# City of Alexandria, Virginia

## MEMORANDUM

**SUBJECT:** 2<sup>nd</sup> CONCEPT REVIEW OF 805, 809, 811, 815, and 823 NORTH COLUMBUS  
STREET  
BAR #2021-00048

## Site Plan Comparison

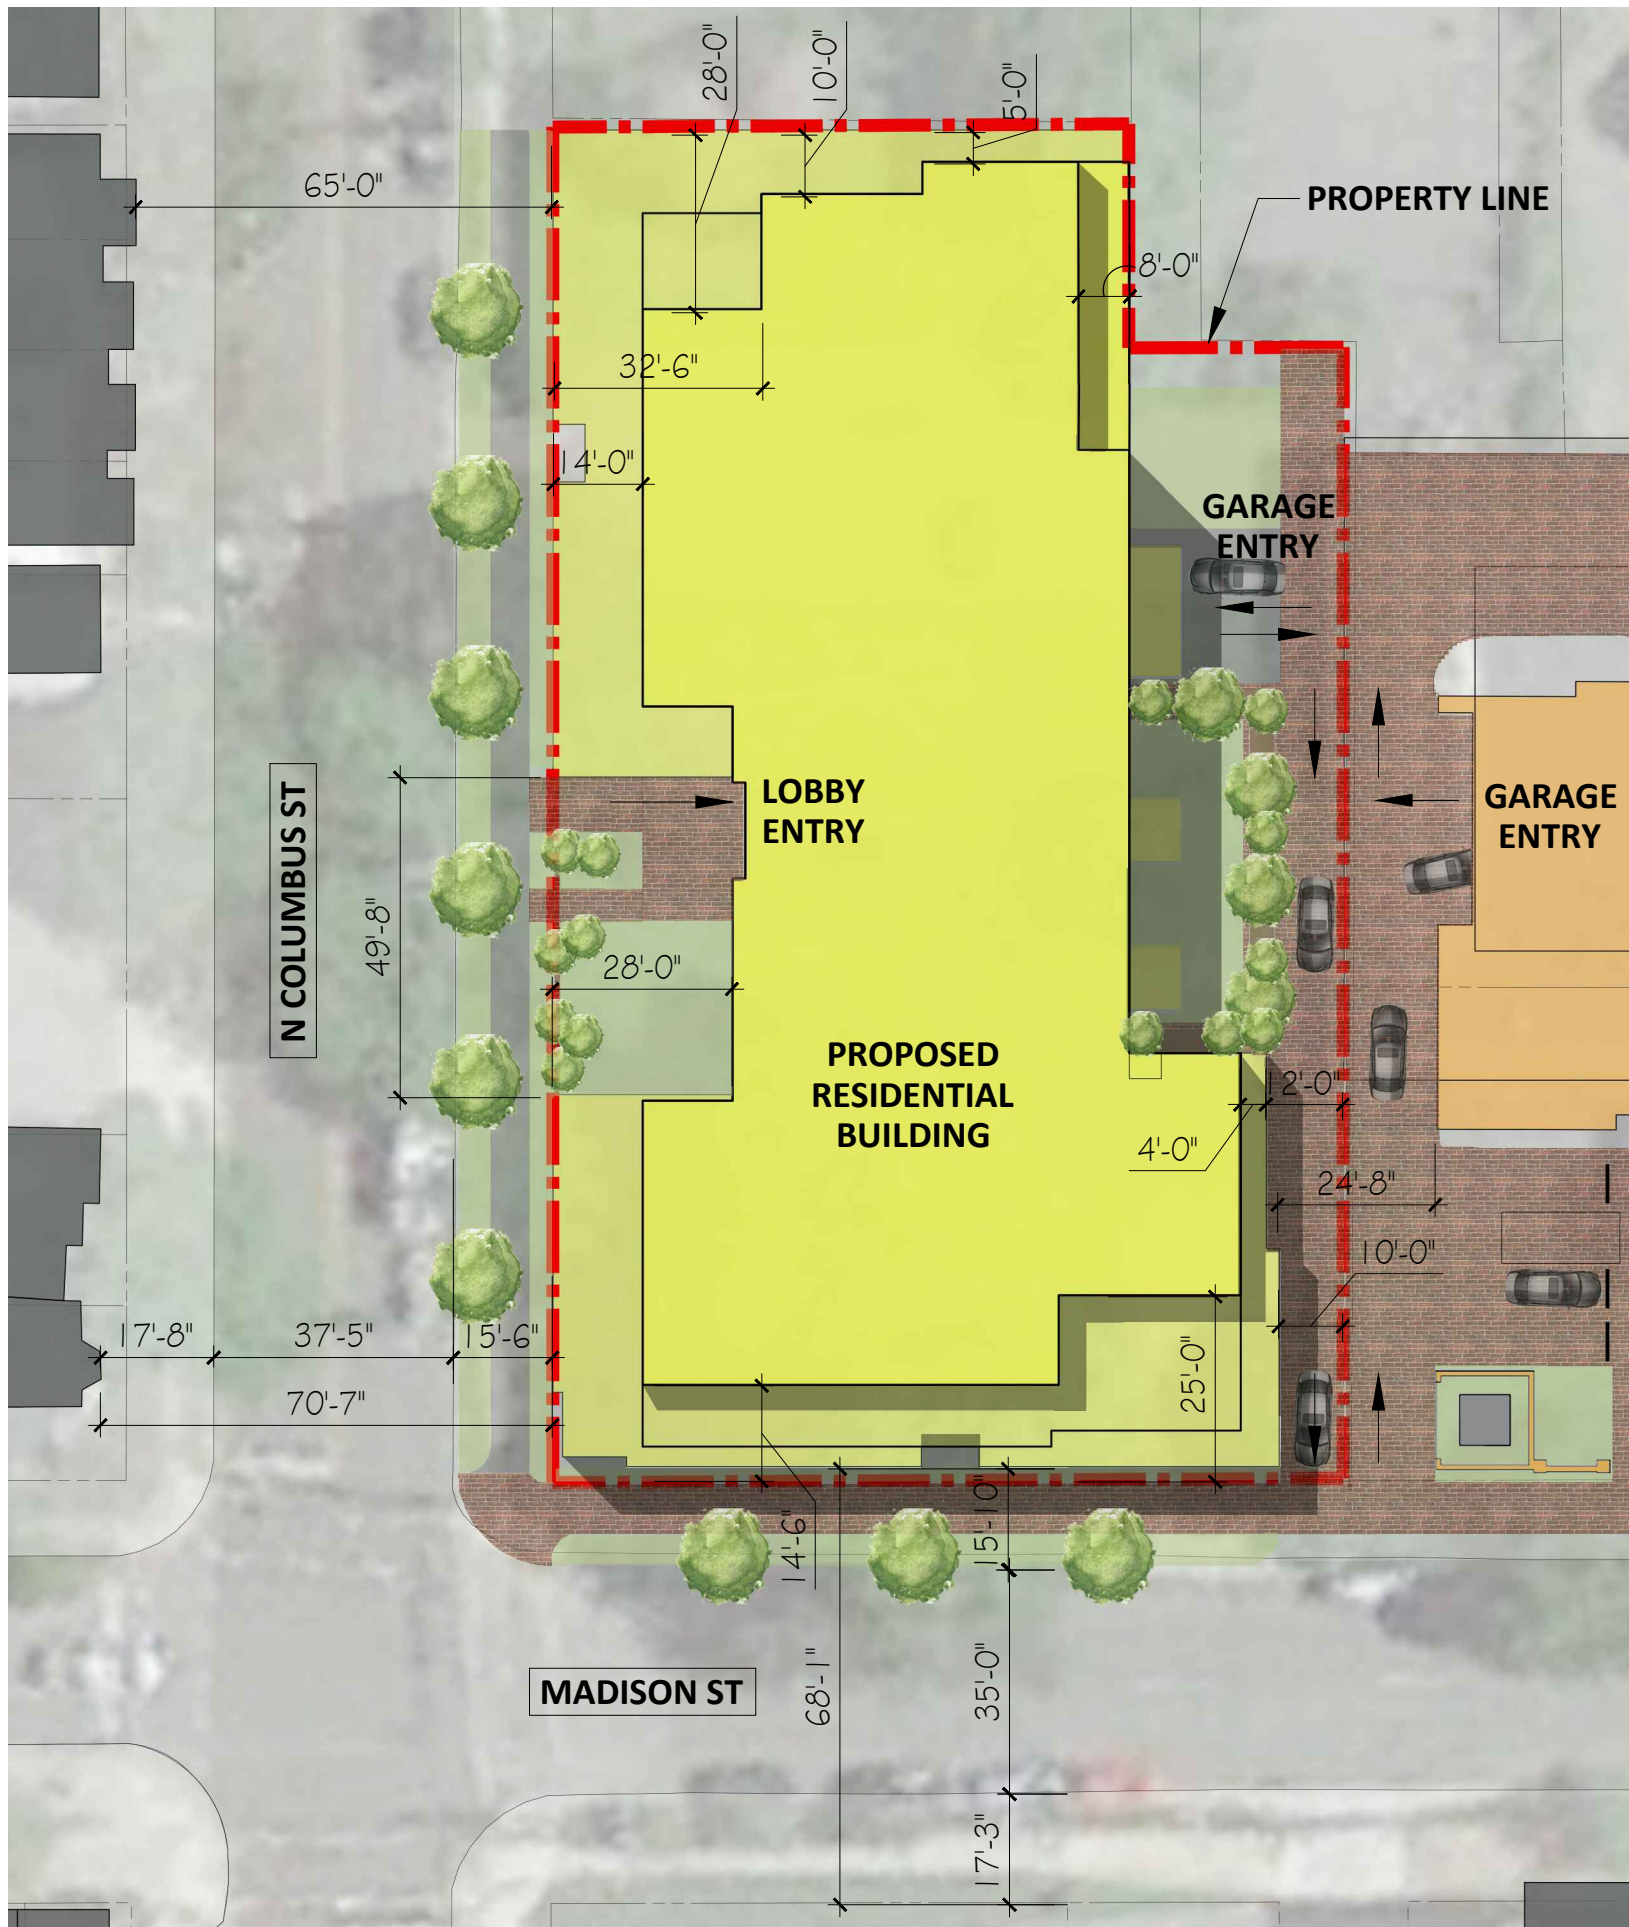
In response to Board comments, the applicant has modified the design to move the 5-story portion of the building to the east as far as possible while still meeting the zoning requirements for open space. In the previously submitted design the face of this portion of the building was located 14 feet from the face of the lower portion of the building, on the west property line. In this design the courtyard at the building entry was approximately 60 feet wide by 14 feet deep. The revised design moves the taller portion of the building an additional 14 feet away from the property line for a depth of 28 feet. The applicant has also extended the length of the three-story massing at the north end of the site by approximately 10 feet in order to resolve some elevational issues. In the proposed design, the entry courtyard is approximately 50 feet wide by 28 feet deep (Figure 2). This additional depth and change in proportion creates a more generous entry court while also moving the tallest part of the building away from the single-family homes across North Columbus Street.

N. COLUMBUS ST.- EAST ELEVATION OVERALL 1:60

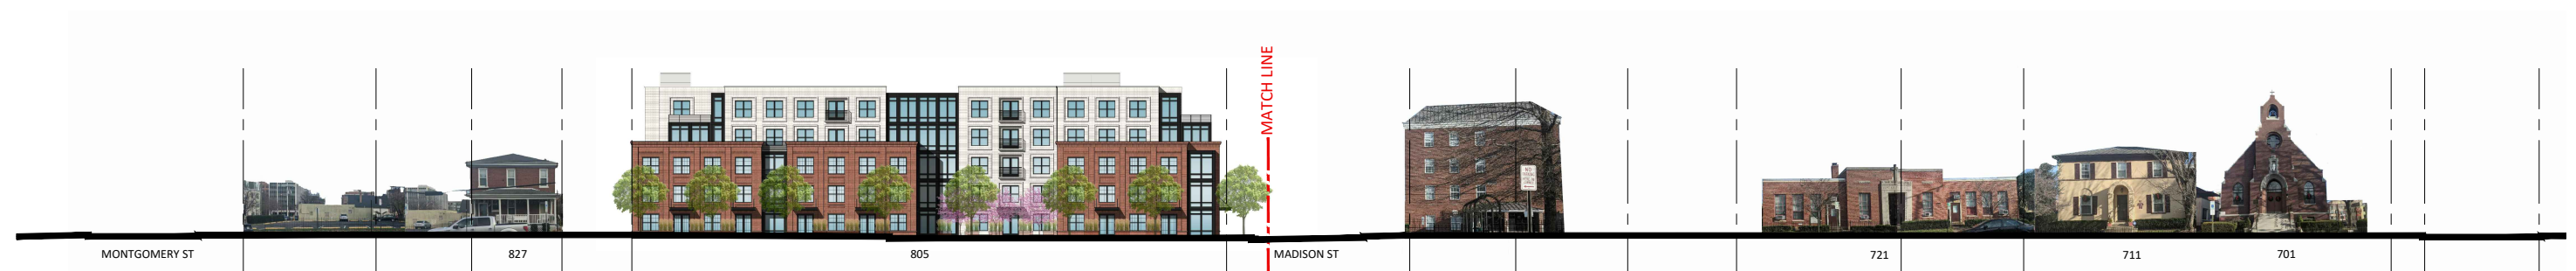
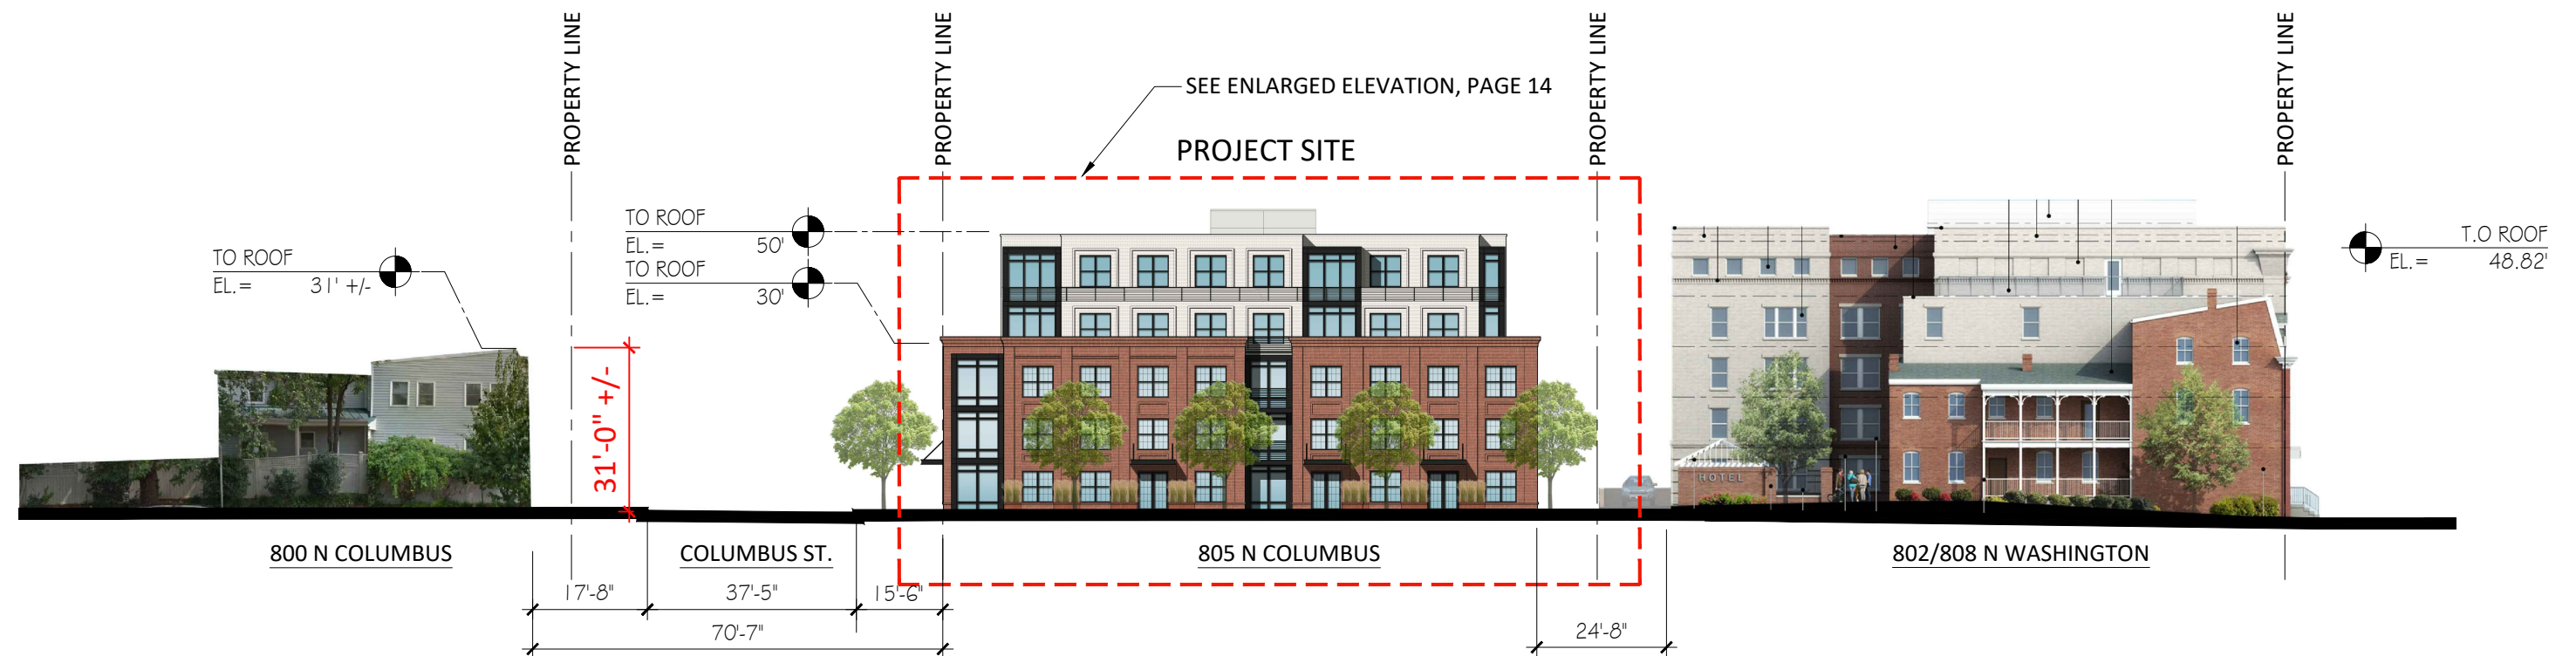
Numerous changes have been made to the North Columbus Street elevation to address comments from the Board about the historic references on the lower portion of the building and the flat quality of the background part of the building (Figure 4). The applicant has also addressed the questions

about the defined entry by expanding the hyphen between the north and south sides of the building and using a darker color. On all parts of the building the previously proposed three-part windows have been replaced with square four-part windows with intermediate mullions on the three-story portion of the building.

The character of the three-story portion of the building has been modified to be more reminiscent of the historic Parker Gray school, see attached photo, than the industrial buildings more commonly found at the waterfront. The northern wing has been expanded by an additional bay in order to create a symmetrical elevation of four bays on each side centered around a recessed dark metal element. The brick piers and metal railings at the top of the building have been replaced with a continuous brick cornice. The grading in this part of the building has been modified to allow for the introduction of entries directly from the sidewalk into ground floor units, making for a more inviting streetscape. At the south end of the building, the applicant has introduced a black metal and glass corner element. The top of this element is lower than the adjacent cornice and is recessed in plan from the three-story massing to give it the feeling of being recessed from the heavier brick forms.

The five-story portion of the building has also been revised and holds more visual interest than the previous submission. The light grey metal sections have been replaced with black metal forms similar in color to the corner element and the windows. These form a stark contrast with the light-colored brick on the rest of the five-story massing. At the southwest corner of the building these forms seem to cascade from the upper form to the newly introduced corner element. In order to address comments about the flatness of the elevation, the applicant has replaced the Juliet balconies with recessed balconies with dark metal railings. These give a depth to the elevation not previously seen on the project. The revised design also includes projecting brick frames around each now four part punched window to accentuate the impression of greater depth for the exterior wall.

During the previous hearing, the Board commented that the applicant should explore ways to accentuate the main building entry. The Board also suggested that direct entry from the sidewalk into ground floor units would help to make the building more friendly to the street. In response, the applicant has modified the Columbus Street elevation to enlarge the recess for the main building entry and change it from a light color metal to a black metal similar to the color of the windows. In addition, the enlargement of the depth of the entry courtyard helps to define this as the clear building entry. In order to allow for the inclusion of unit entry doors to the ground floor units, the applicant has modified the grading and is now able to include them for all parts of the Columbus Street elevation. The inclusion of recessed black metal bays in the three-story parts of the building helps to break up this massing and is effective in terms of providing visual interest to the building. They do, however, appear to be main building entries and are in competition with the main entry at the courtyard (Figure 7). The applicant should explore ways in which these elements can be differentiated from the main building entrance while still achieving the effect of breaking up the building massing.

1- SOUTH ELEVATION - MADISON ST

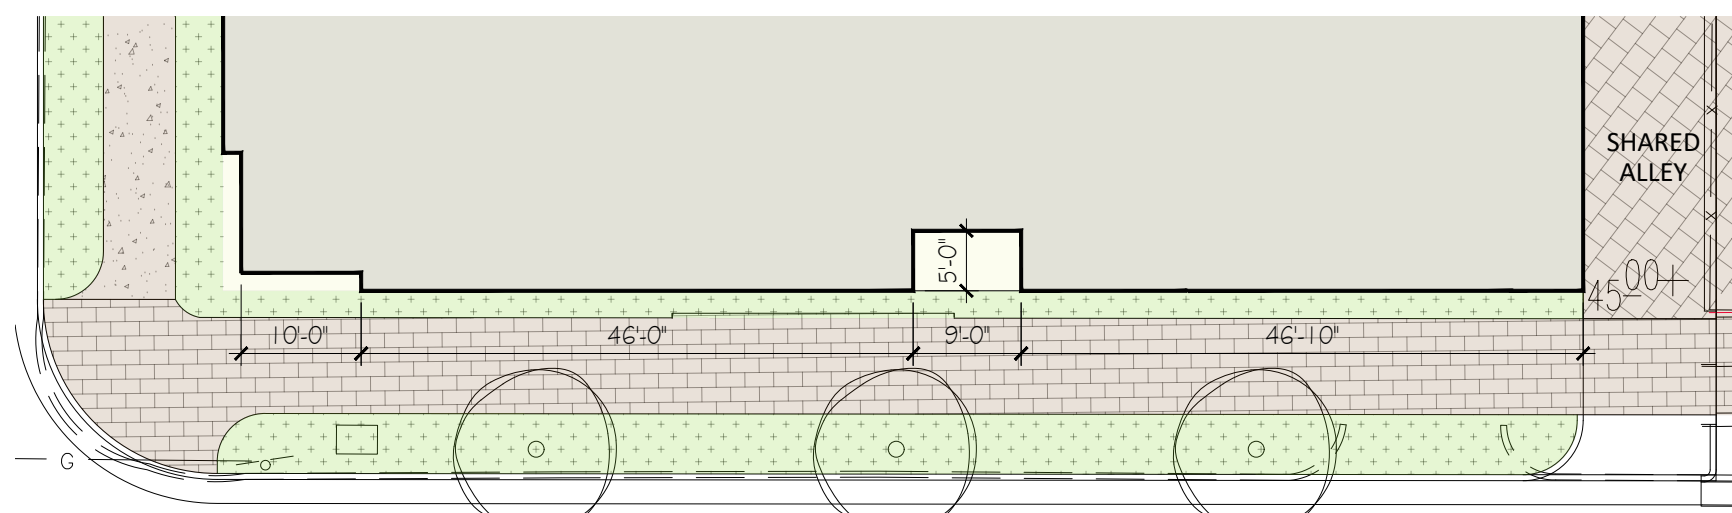
The changes to the Madison Street elevation are similar in scope and effect to those on the North Columbus Street elevation (Figure 5). The step in the building located three bays in from the east end of the elevation has been removed. In an effort to break up the repeating bays on this elevation, the applicant has created 2 four bay sections on either side of a recessed black metal bay similar to the one on the north side of the west elevation. The upper two floors have been broken into a four-bay section at the west side and a two-bay section at the east side, centered around a black metal bay, with black forms at both the south west and south east corners. The overall effect of these revisions is to turn the south elevation from a series of simple bays to a more complex arrangement of bays. The symmetrical appearance on the first floor is a nice counterpoint to the asymmetrical forms on the upper level.

2- NORTH ELEVATION

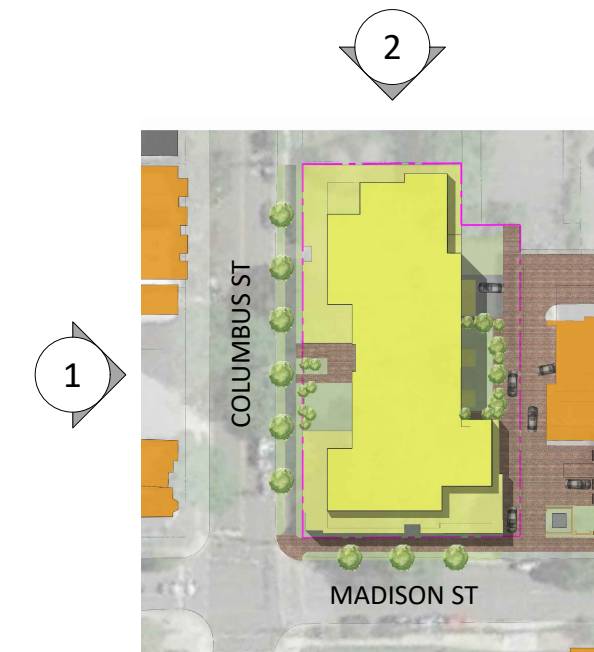
The building as proposed is directly on the north property line, making it impossible to include windows on the lower levels. The applicant has addressed this on the east side of the lower level by including recessed brick panels in a pattern that is similar to the fenestration pattern of the rest of the building. The east end of the lower level does not have such brick panels. The upper levels in this area are stepped back from the property line and in some areas can have additional windows. The black metal corner piece at the east side of the upper levels is effective in providing visual interest to the north elevation but the remainder of the north elevation on the upper levels is devoid of architectural features (Figure 9). The applicant should explore ways to include additional windows or other architectural elements to these areas to improve this elevation that will be visible from the entire north side of the block.

1- EAST ELEVATION - ALLEY

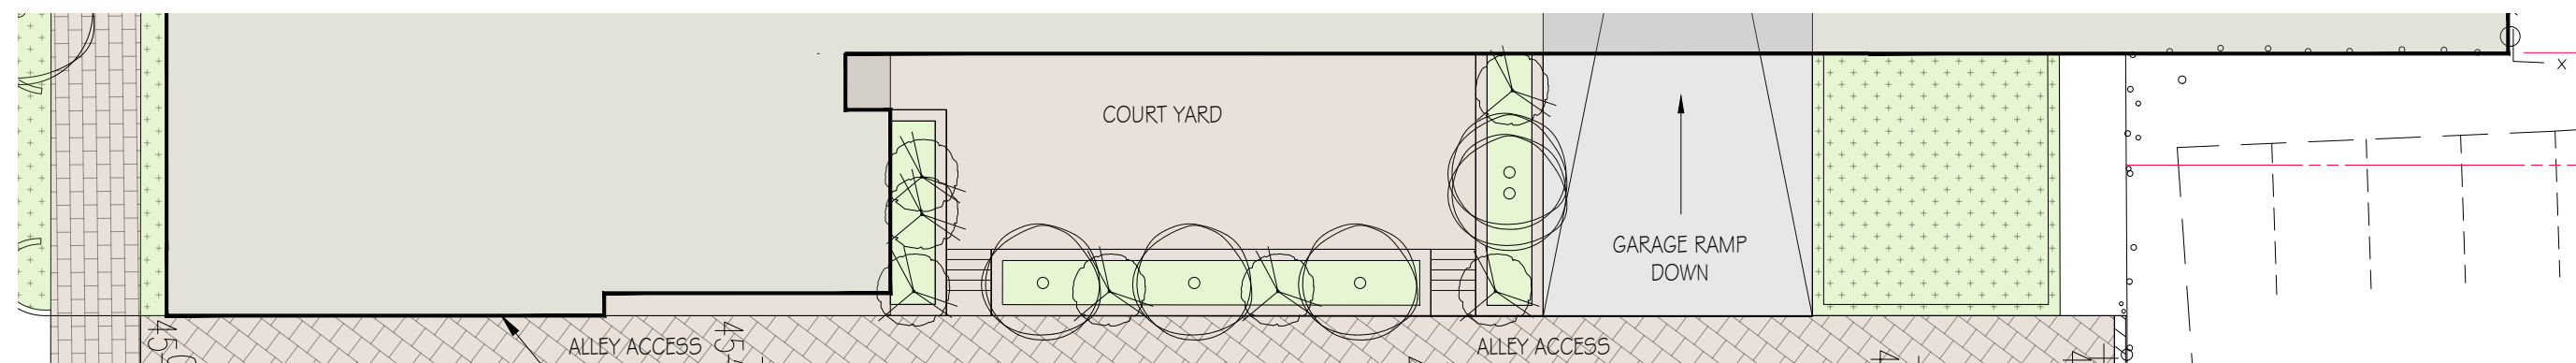
The alley elevation has been modified from the previous submission but mostly to be consistent with the other elevations (Figure 6). It remains relatively simple with forms extending around from the other elevations flanking a simple field of punched windows. As with the west and south elevations, the windows on this elevation have been revised from three vertical strips with a smaller horizontal section at the bottom to square four-part windows in order to bring some continuity to the different parts of the building. The other significant change to this elevation is that the

cantilevered balconies with glass railings have been replaced with black metal balconies supported by vertical columns and horizontal black railings. In two locations these are in a single bay wide configuration and another is two bays wide centered above the garage entry.
